# Kevin Rosengren & Associates Pty. Ltd.

### **MACRAES GOLD MINE - FOOTWALL FAULT PEER REVIEW OF PSM REPORT**

This report presents a peer review of the Pells Sullivan Meynink (PSM) report (Ref. 1) concerning likely ground movement on the Footwall Fault, resulting from proposed cut-backs of the Round Hill and Southern open pits. The review is based on information in the PSM report (Ref. 1), together with our knowledge of the area and other information provided by Oceana Gold (NZ) Limited (OceanaGold).

**Fig. 1**

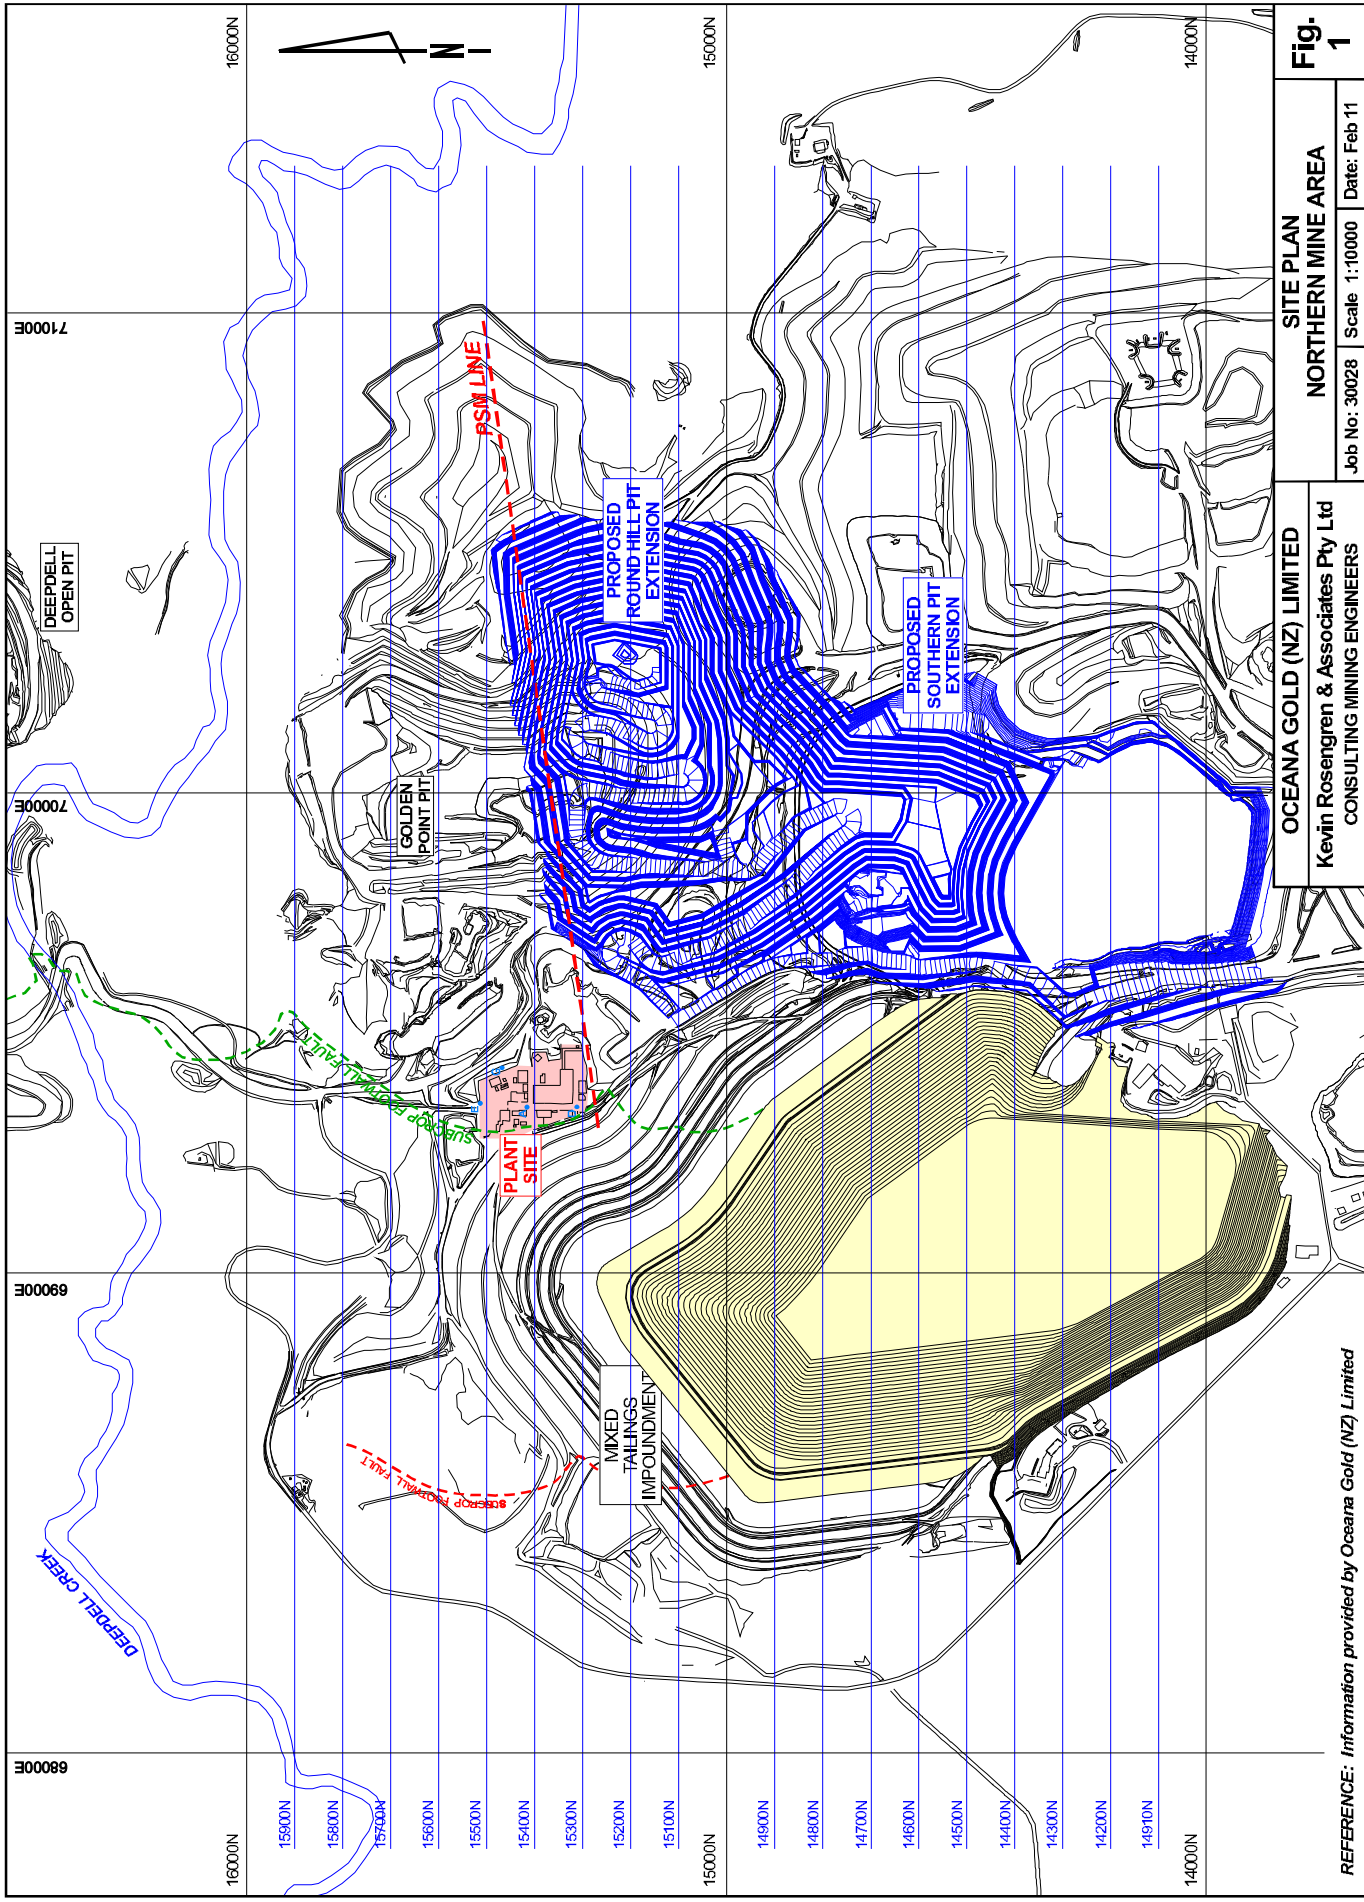
If there were no restraints, the pit cut-back would extend further to the north, to include the Golden Point open pit. However, because of concerns about the influence of such mining on the stability of the processing plant, the northern limit of mining has been specified by a "PSM Line" at approximately 15250N (Ref. 1), (Figs. 1 and 2).

- reducing depth of mining to RL350, or
- restricting mining south of the PSM line (Figs. 1 and 2).

<b>OCEANA GOLD (NZ) LIMITED</b> Kevin Rosengren & Associates Pty Ltd CONSULTING MINING ENGINEERS	<b>CROSS-SECTIONS</b> 15100N, 15200N		<b>Fig-6</b>
	Job No: 30028	Scale 1:4000

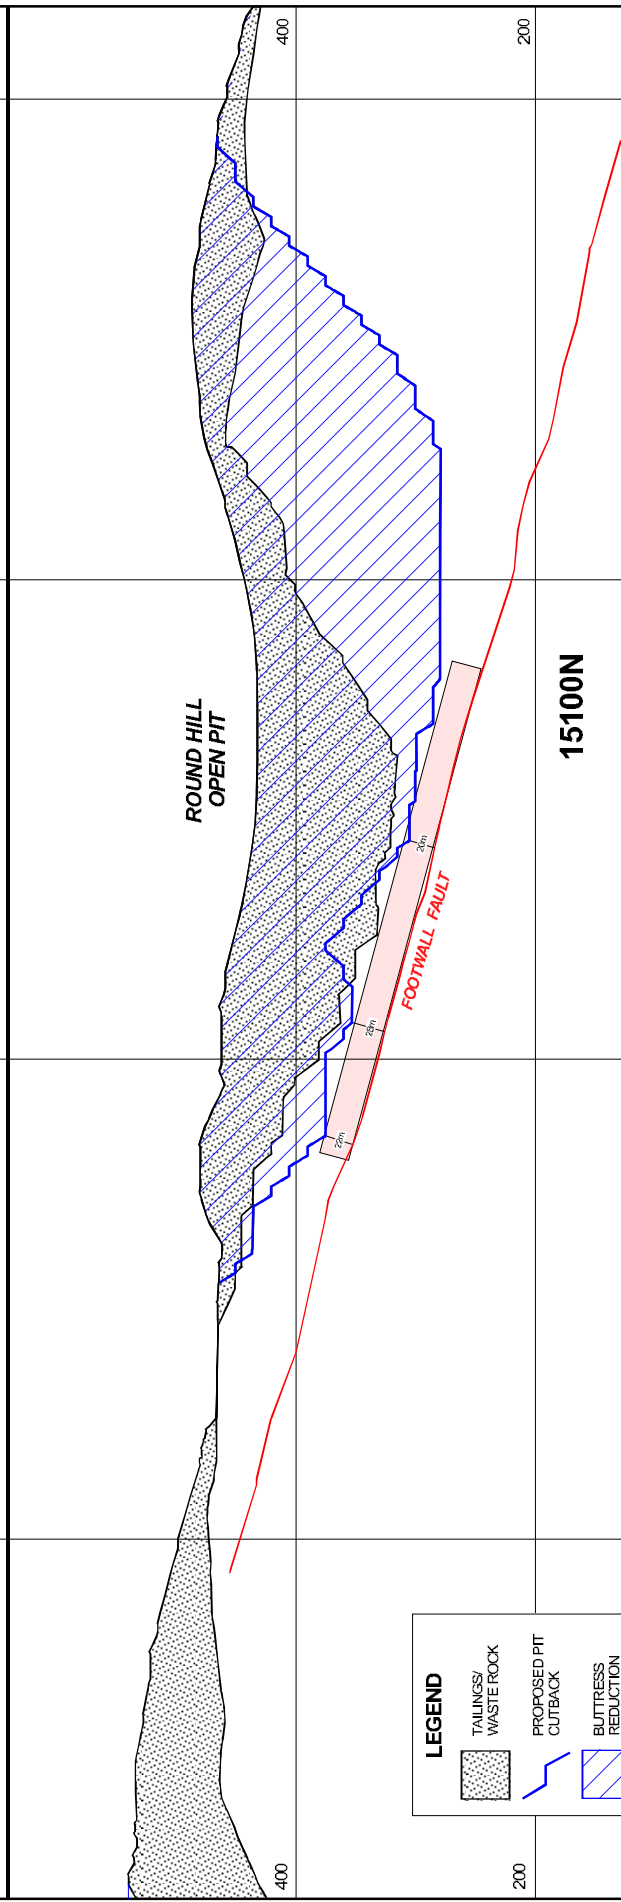
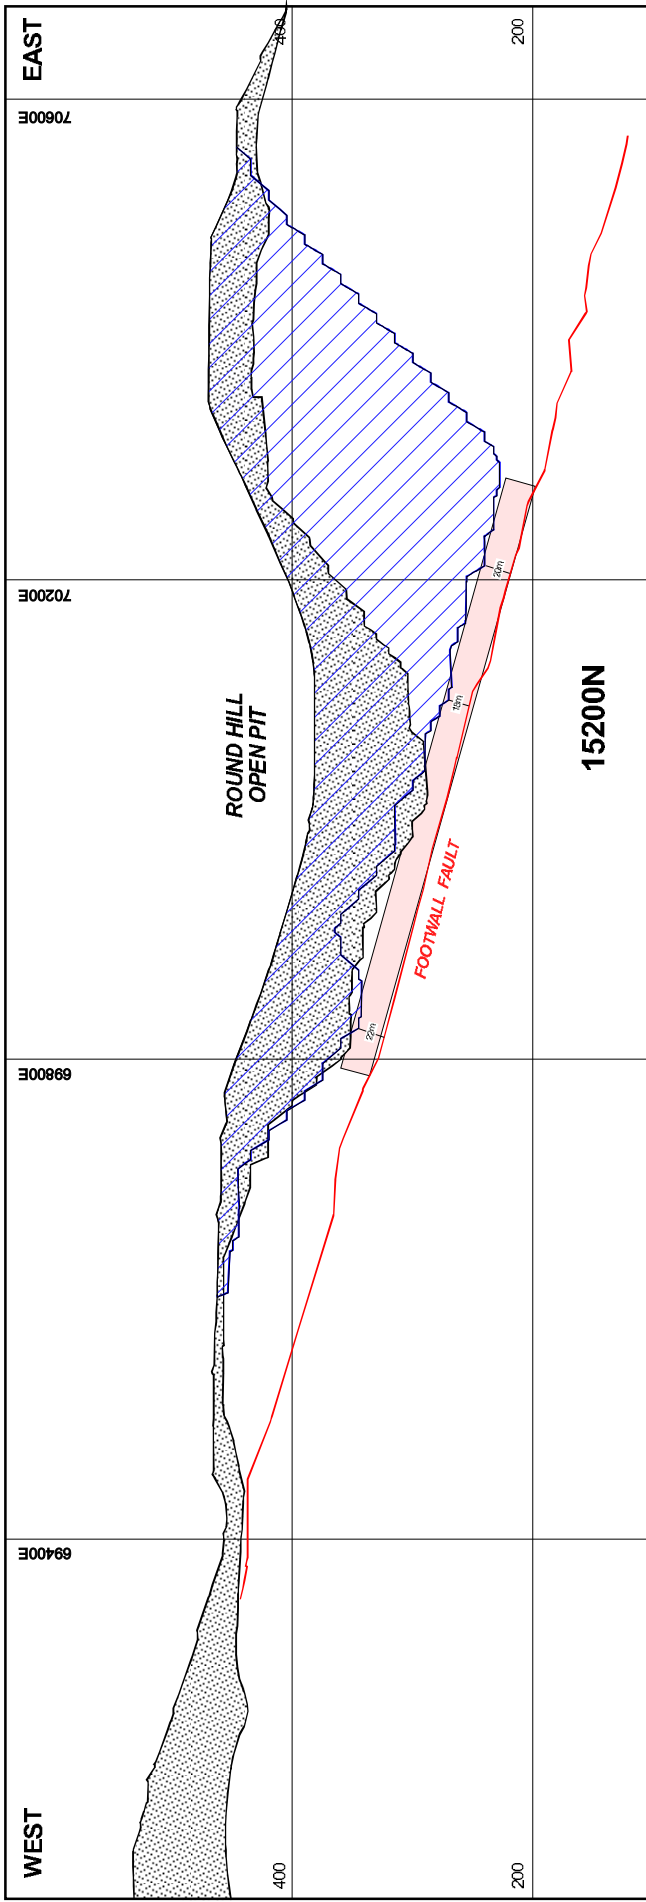
The cross-sections (Figs. 4 to 6) show that the Footwall Fault continues beneath the MTI, south of 15200N. With movements of several metres predicted in this area, there will be substantial cracking of the base of the MTI, with direct connection to the Footwall Fault. It is planned that the MTI will be decommissioned but, if it is not completely dewatered, it will provide a source of constant recharge to the fault, which will potentially generate even larger movements.

In our opinion, the issue of water pressures in the Footwall Fault, generated by the saturated tailings in the MTI undercut by the Footwall Fault, is of major importance and could lead to much larger ground movements than those currently predicted. It is recommended that a detailed study of the matter, including measures which can be taken to reduce the influence of the tailings, be undertaken before the proposed cutback of the northern pits commences.

**Fig. 7**

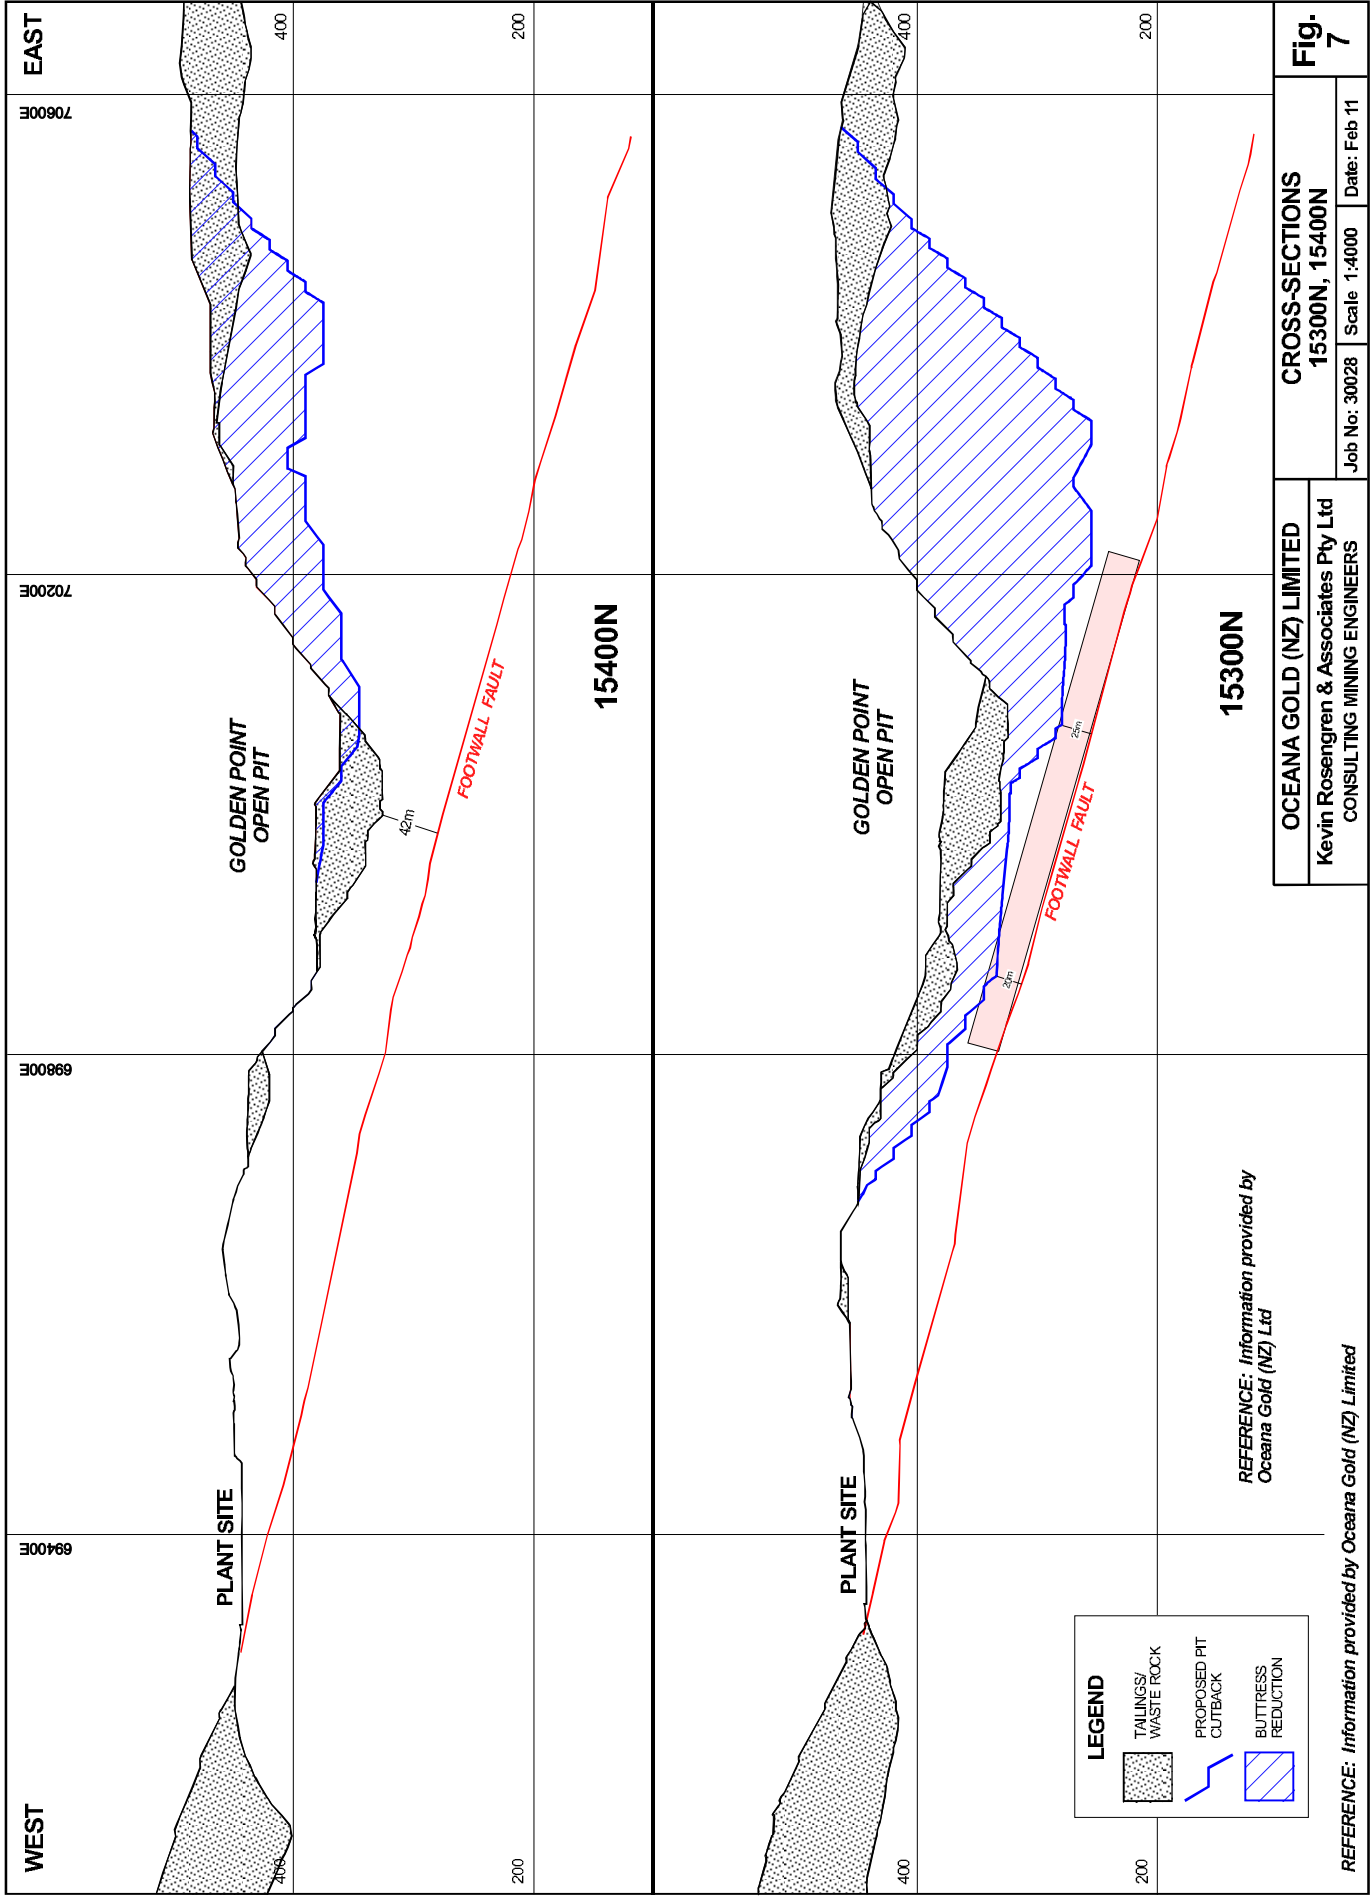
For this reason, the proposal to limit the northern extent of mining, to protect the plant site is a sound approach. Whether the PSM line is an adequate limit is another question. The cross-section at 15300N (Fig. 7), beyond this nominal limit and at the southern limit of the plant site, shows that there is substantial buttress reduction ( $80,000\text{m}^3/\text{m}$  strike length) and a relatively high buttress reduction ratio (4000m) on this section. Furthermore, the floor pillar has a minimum thickness of 25m and a slenderness ratio of 17 to 1. We would not be confident that this mining will have minimal impact on the plant site.

<b>OCEANA GOLD NZ LIMITED</b>	<b>MOVEMENT MECHANISM</b>		<b>Fig. 14</b>
Kevin Rosengren & Associates Pty Ltd CONSULTING MINING ENGINEERS	ob No 30028	Scale 1 2500

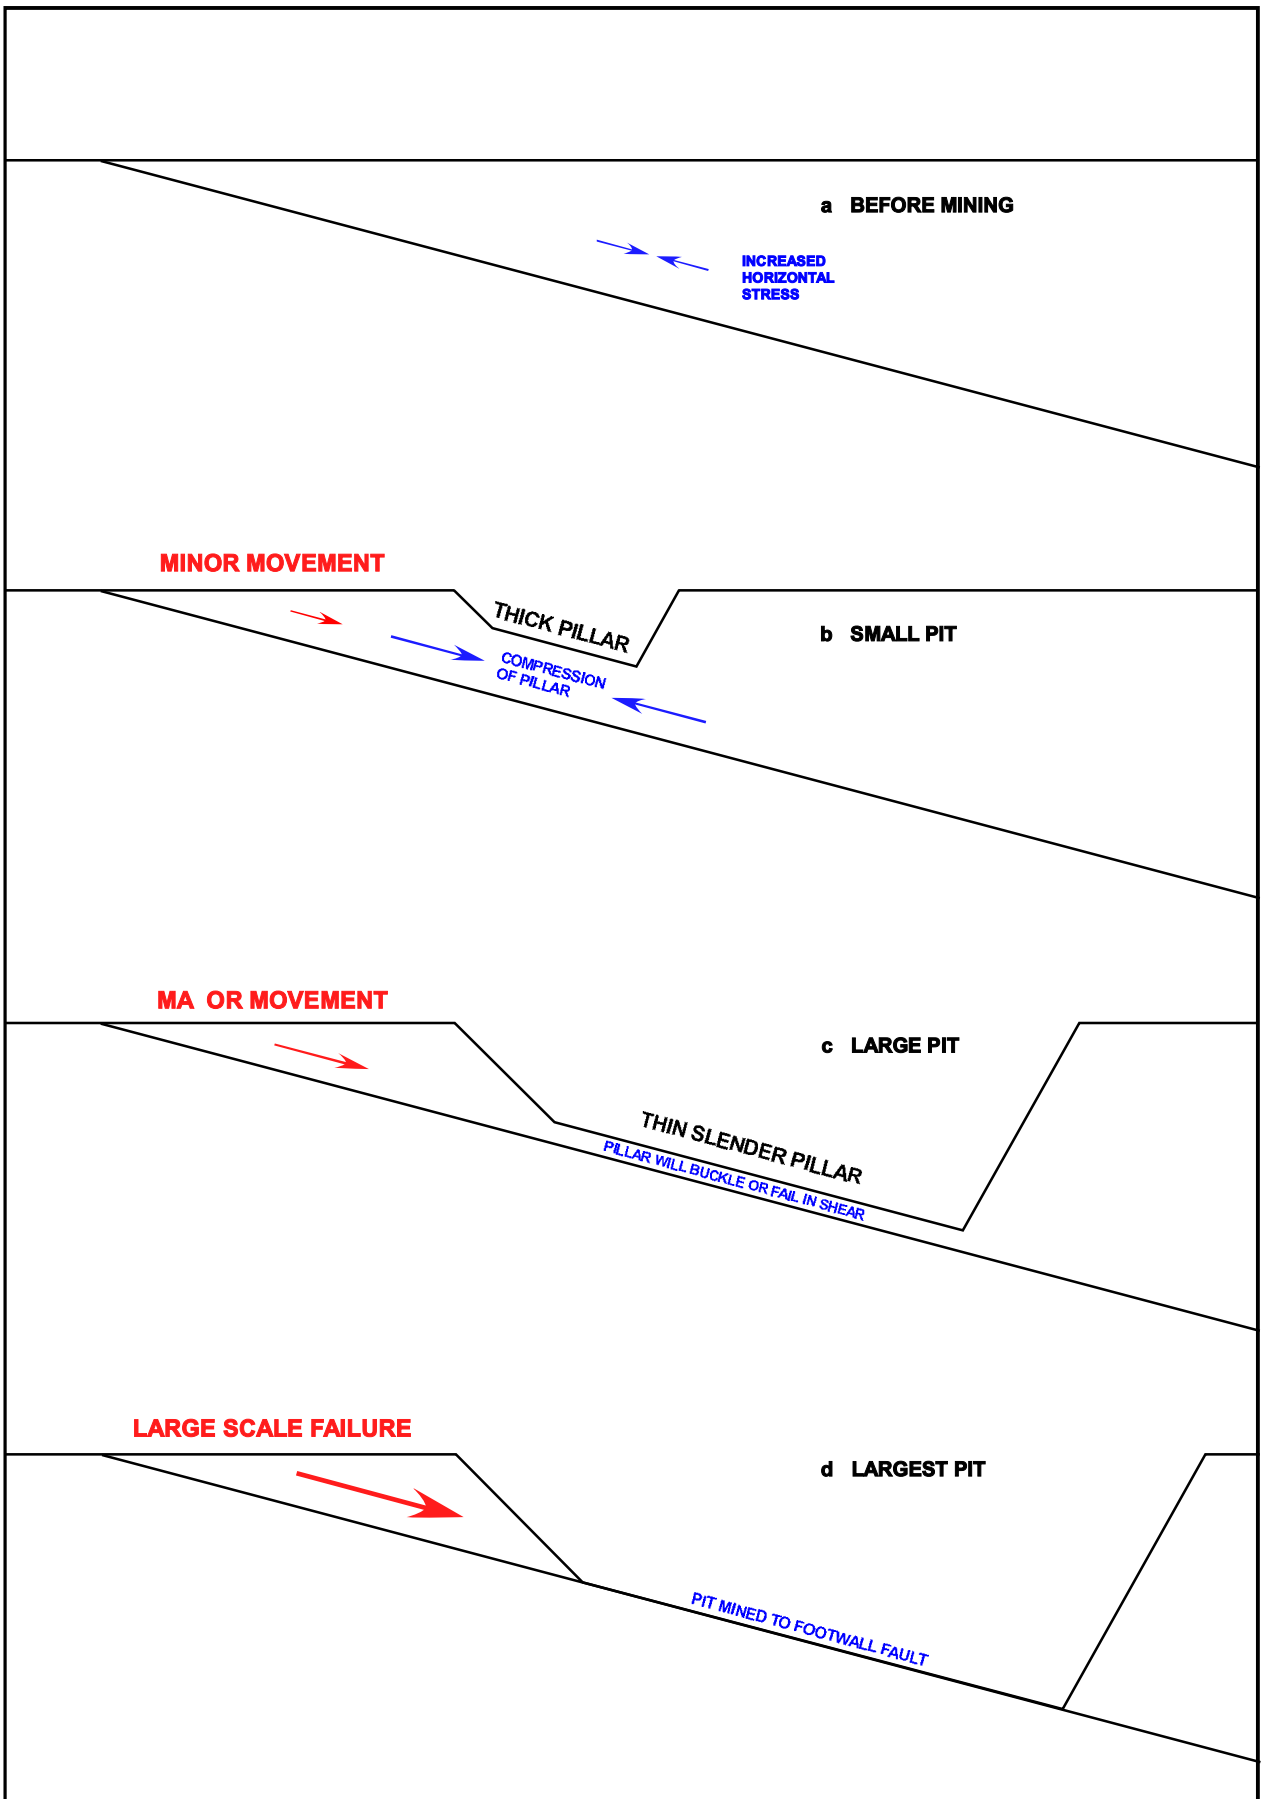
Note that Fig. 14 shows a two dimensional slice without side restraint and applies strictly to a pit with significant strike length. The lateral restraint is the reason why the Round Hill pit caused such minor movement, even though it was mined relatively close to the Footwall Fault (Figs. 6, 7). As discussed above, in our opinion, the increase in strike length of mining is also the reason why such large movements are being experienced at Frasers South.

It should also be noted that it is planned that both Frasers and Frasers South open pits will be mined down to the Footwall Fault (Fig. 12). This will be equivalent to Stage 4 of Fig. 14 and will generate large scale movements in the footwall area. This may be quite acceptable provided that there is no essential infrastructure located in this area.

- (i) This offset distance will still allow significant movement to occur by compression of the 25m thick pillar beneath the open pit. For example, the 4m(H)/1m(V) movements of the plant site occurred with a much larger pillar thickness below the Golden Point pit (Figs. 8 and 10).
- (ii) The behaviour of the 25m thick pillar will be very dependent on the down dip length of the pillar. The longer the pillar, the more slender it becomes and the higher probability it has of suffering buckling or shear failure. For example, the current Round Hill cut-back proposal has 500m long pillars between 15100N and 15300N (refer Figs. 6 and 7). These pillars have slenderness ratios of 20:1 to 25:1 and will have minimal passive earth pressure resistance, even with the minimum pillar thickness of 25m.

However, the final movement will be determined by the final pit geometry after mining, particularly the thickness and slenderness of the final pillar between the pit floor and the Footwall Fault (Fig. 14)
